World Forum for Harmonization of Vehicle Regulations

Proposal for a new supplement to the 01 series of amendments to UN Regulation No. 154 (Worldwide harmonized Light vehicles Test Procedures (WLTP))

Submitted by the expert from the International Organization of Motor Vehicle Manufacturers* **

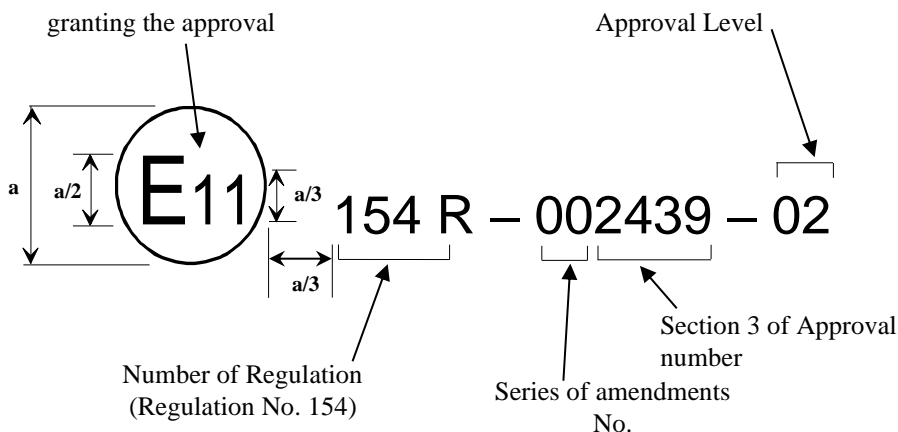
Annex A3, amend the first graphic with a space between 154 and R to read:

Figure A5/14

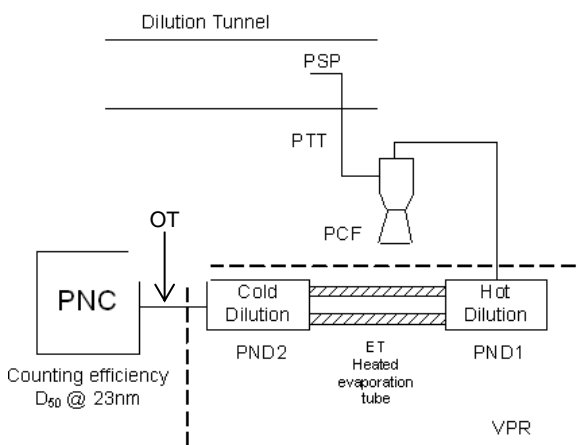
The following paragraph contains the recommended practice for measurement of PN. However, systems meeting the performance specifications in paragraphs 4.3.1.2. and 4.3.1.3. of this annex are acceptable. **See Figure A5/14.**

The evaporation tube, ET, may be catalytically active with a wall temperature of 350 °C (±10 °C)."
